## ADDENDUM

NO. 1

**PROJECT NAME:** Lehman High School 2025 Additions and Renovations

**CLIENT NAME:** Hays CISD

**DEMOLITION PLAN (2 OF 2)**

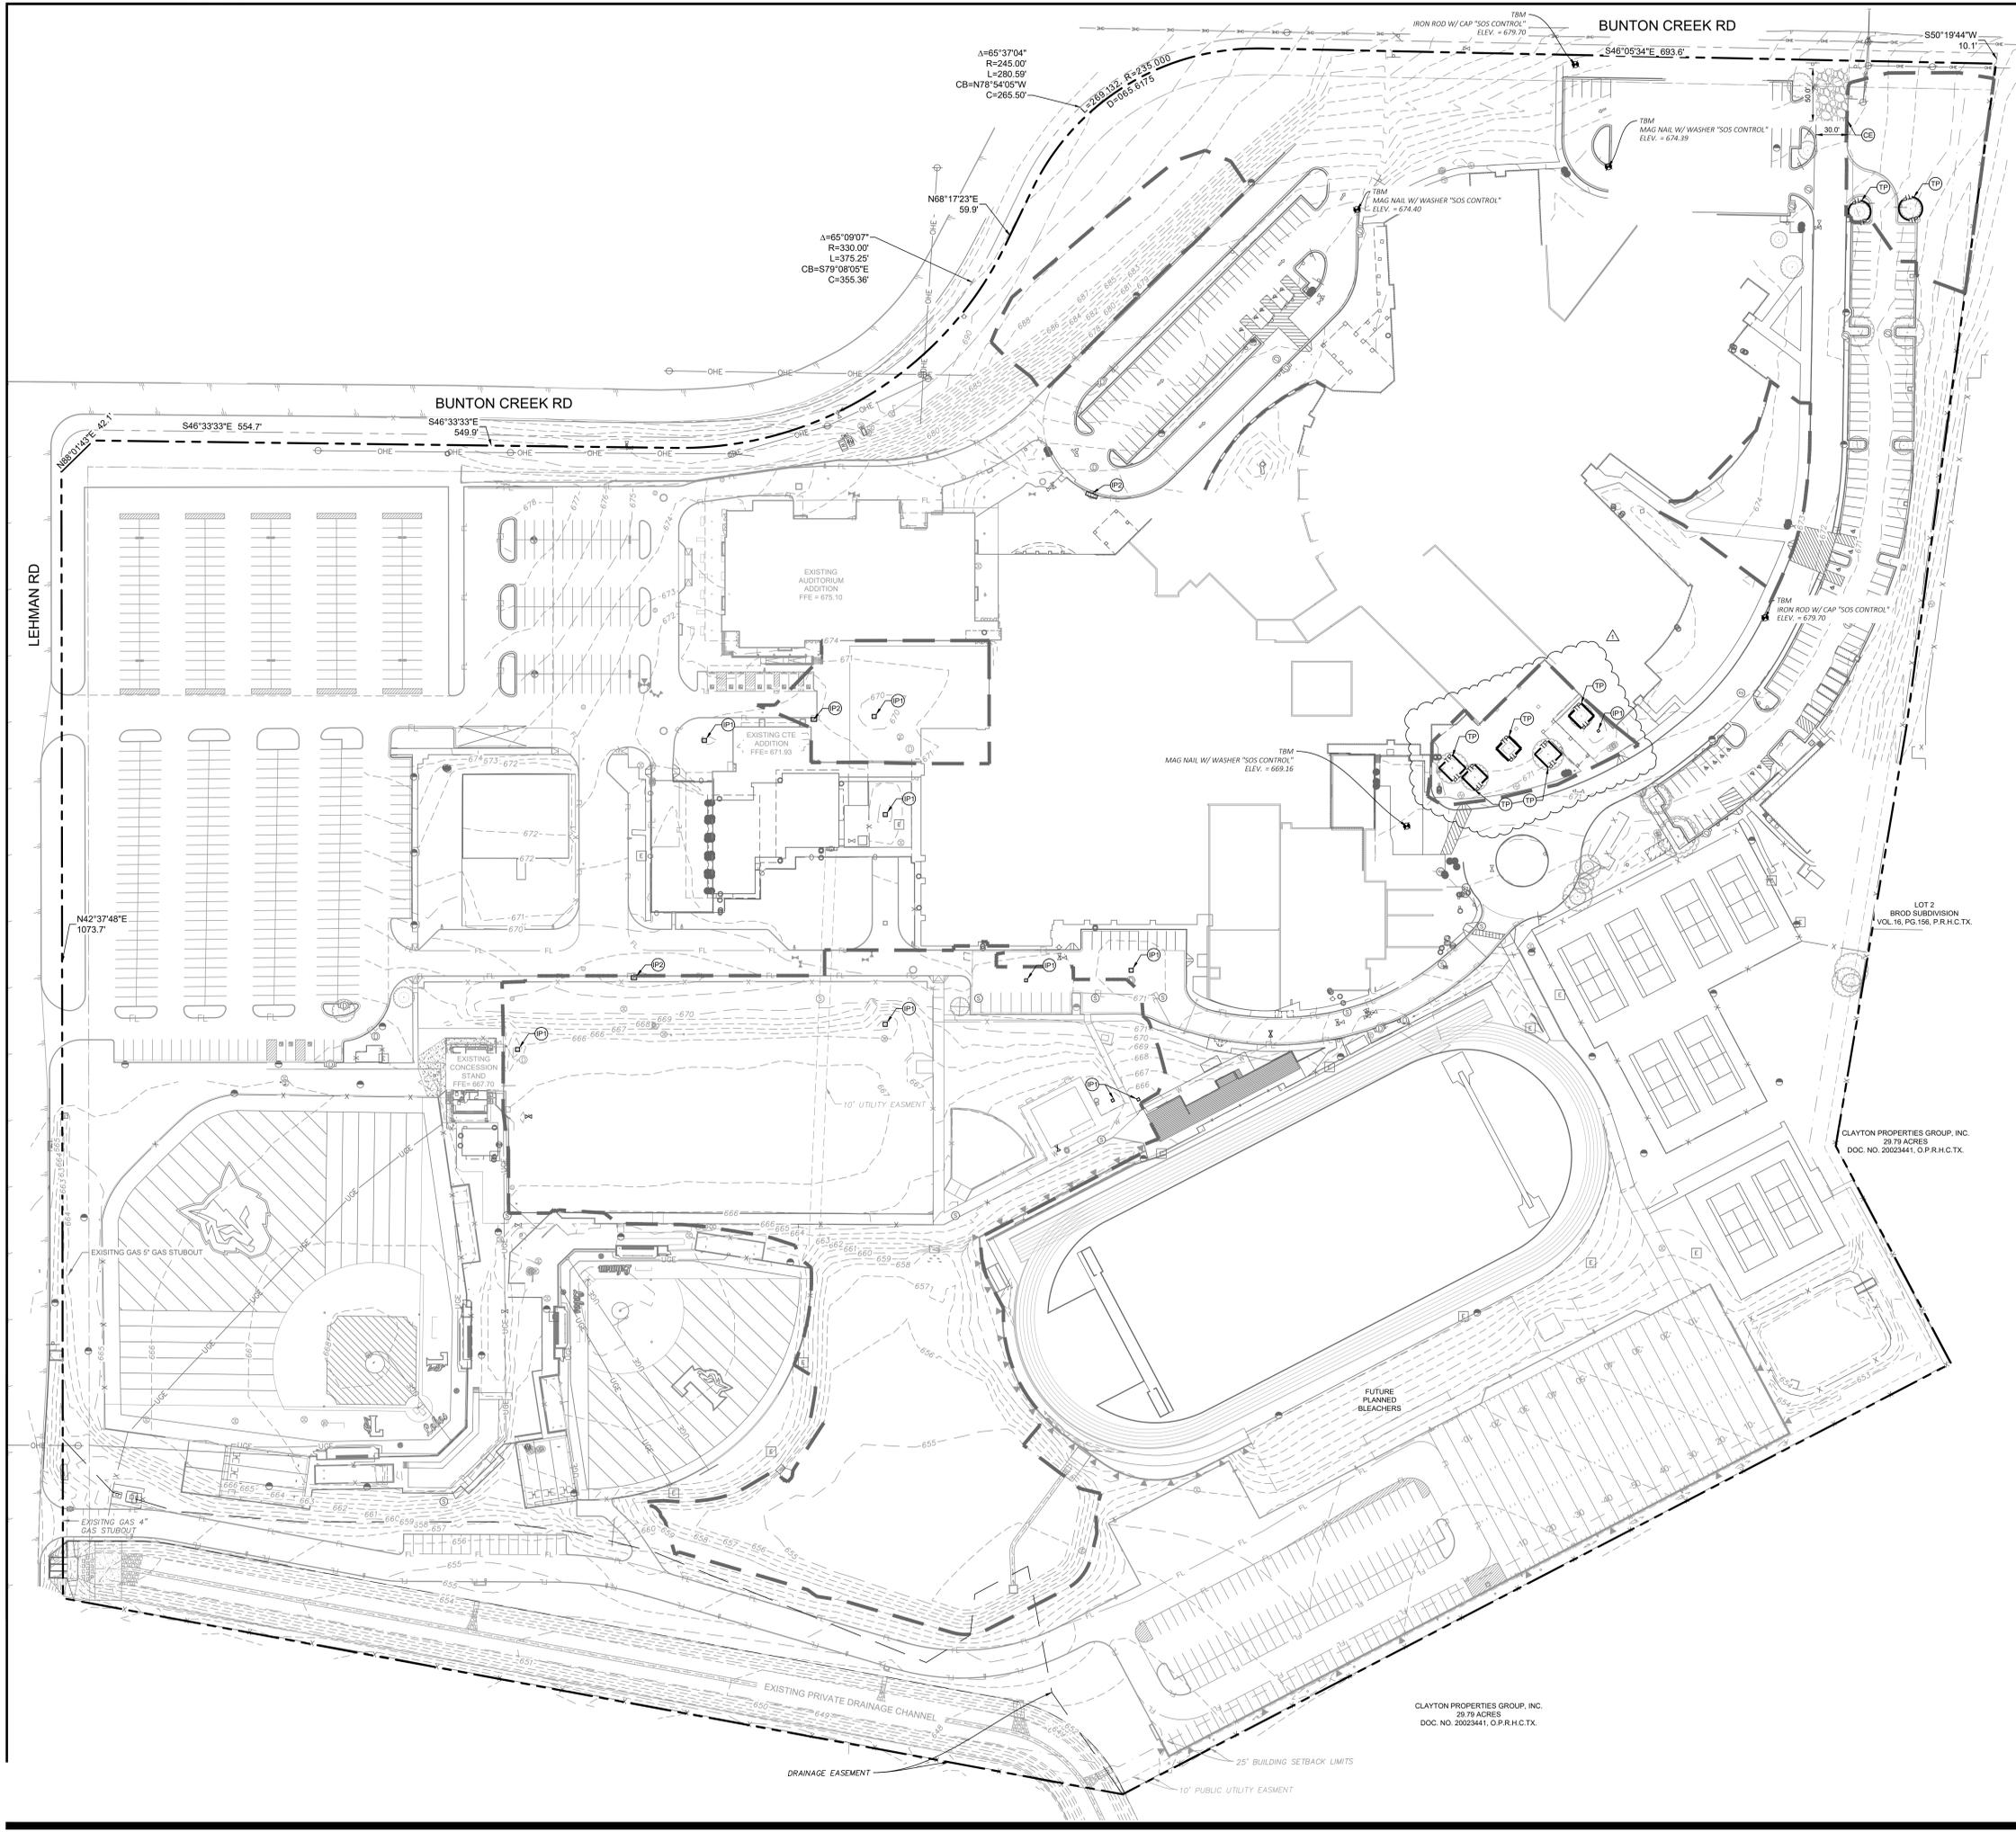
AD No 1, Civil Item 1: To the Drawings, Sheet C2.02, "DEMOLITION PLAN (2 OF 2),"

- 1) Wall and sidewalk added to demolition scope.

PACKAGE	VOLUME
Job No. 01954-08-01	Sheet No. ISSUE FOR BID
Drawn By: RAU	C3.01
Date: 05/08/2025

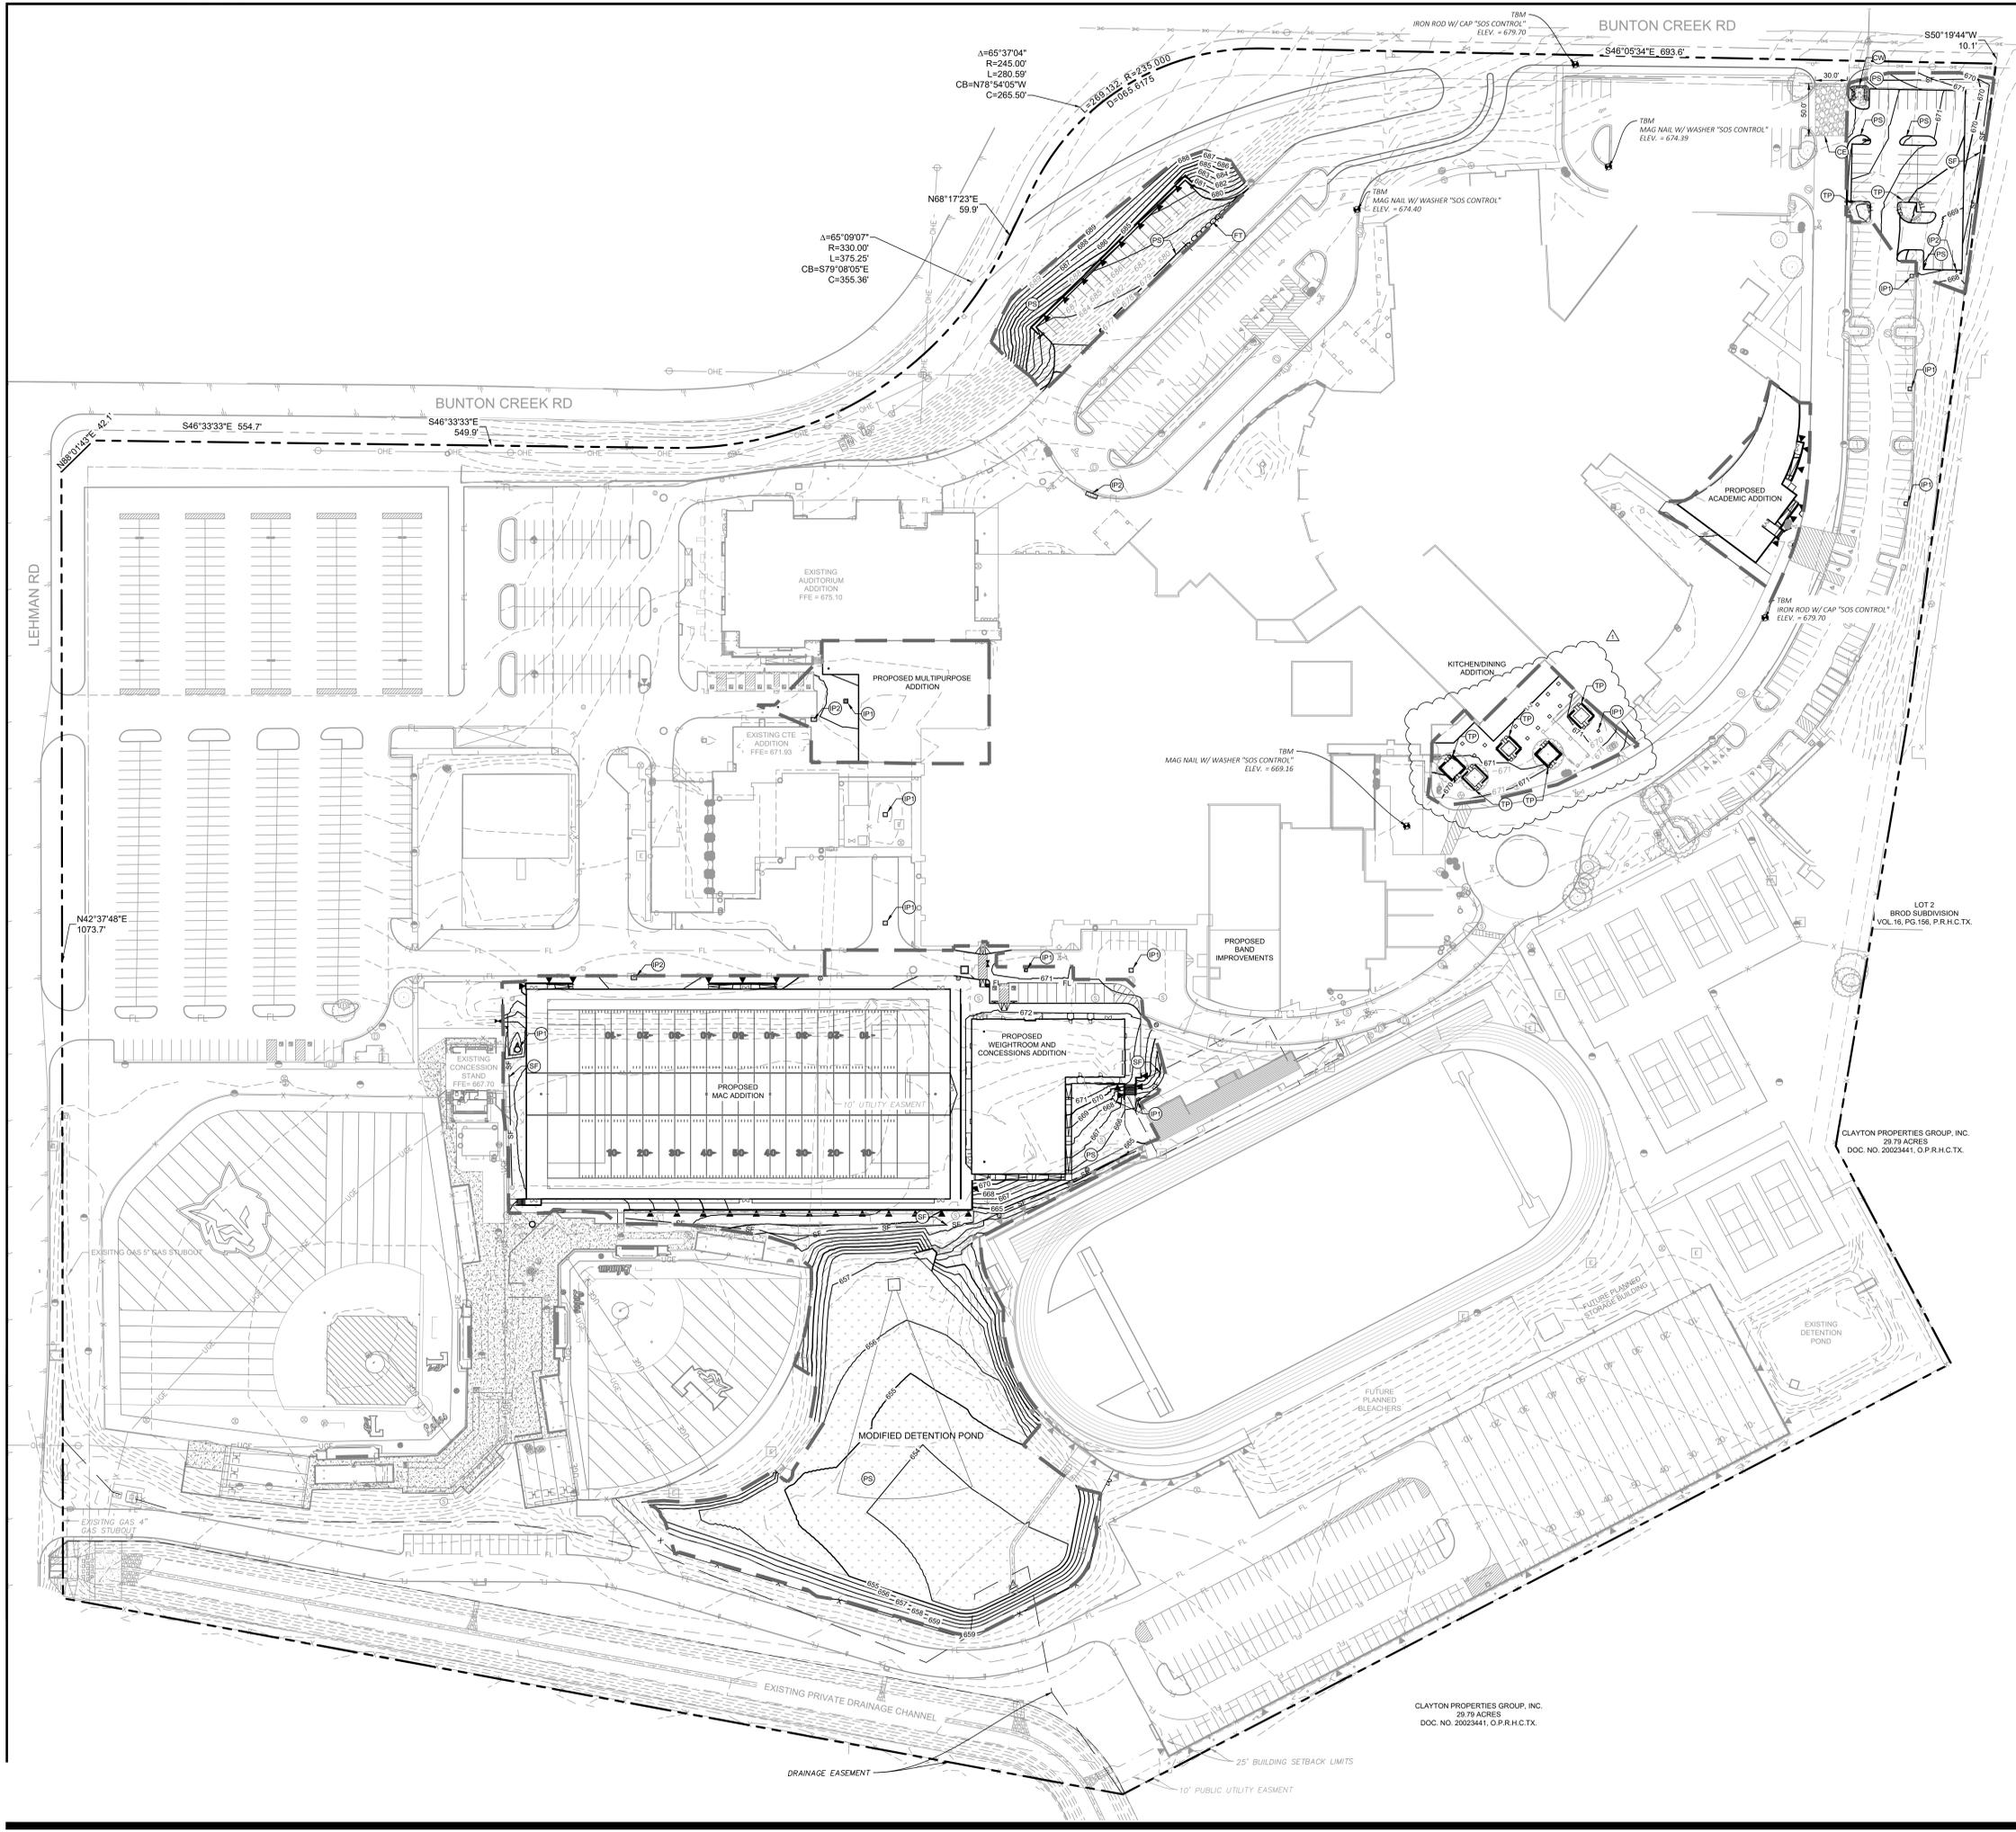
AD No 1, Civil Item 3: To the Drawings, Sheet C3.01, "EROSION CONTROL PLAN PHASE 2,"

- 1) Limits of disturbance increased.

**PAVING PLAN**

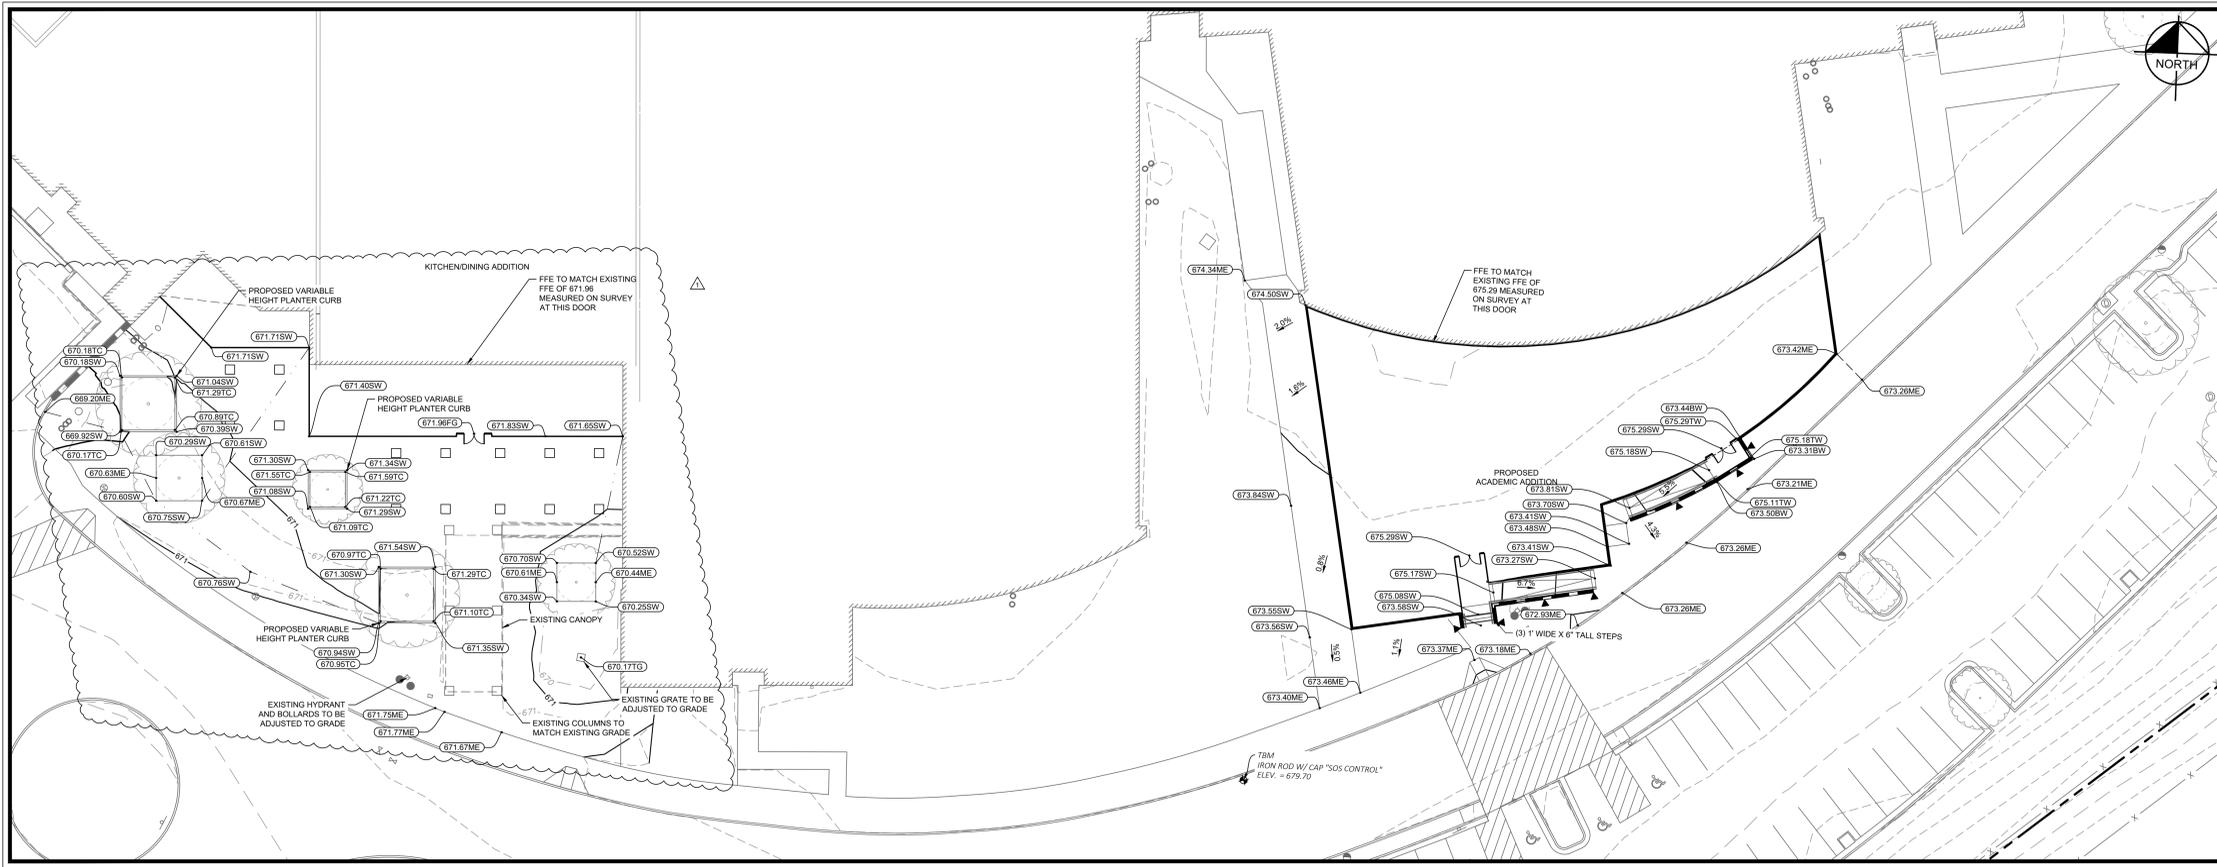
AD No 1, Civil Item 5: To the Drawings, Sheet C5.01, "PAVING PLAN,"

- 1) Additional sidewalk area.
